10/566,639

Office Action Summary	Application No. 10/566,639	Applicant(s) BONNER, MICHAEL R.	
	Examiner Leonard R. Leo	Art Unit 3785

DETAILED ACTION

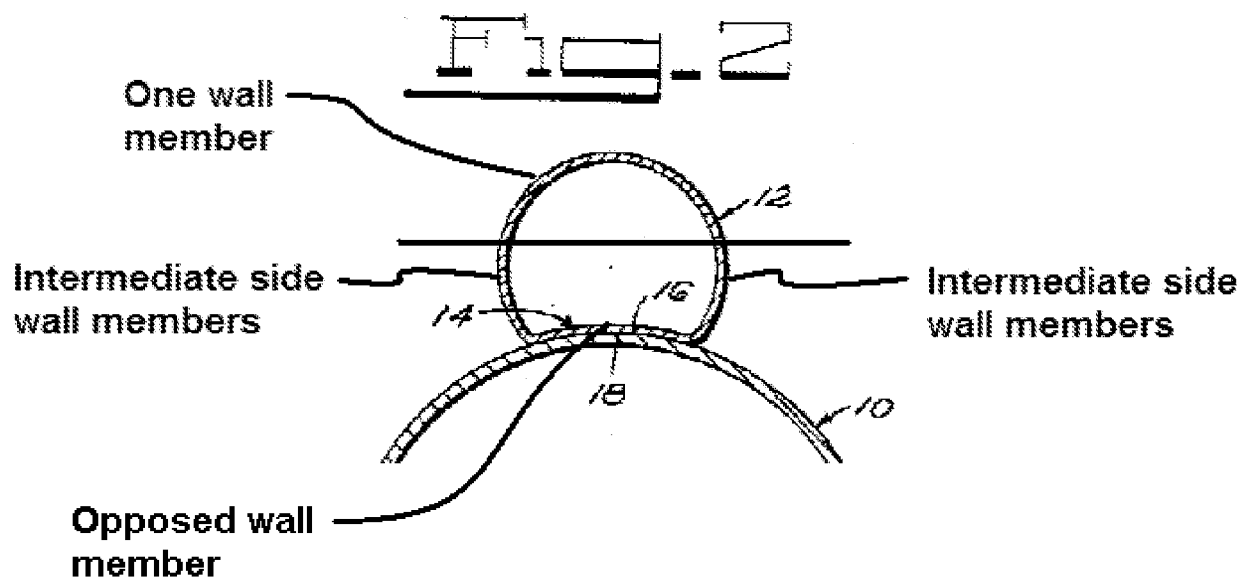
Collito (Figure 2, marked up, next page) discloses a conduit assembly comprising two conduit members 12 having an elongate, flexible fluid-tight wall having at least two opposed wall members, one wall member has a convex outer surface, an opposed wall member has a concave outer surface 16 and intermediate side wall members (i.e. delineated by the line) interposed there between;, defining a non-circular cross section; but does not disclose a polymeric material and a rib/tab.

Regarding claim 21-22, Figure 2 of Collito discloses the first and second walls are arcuate.
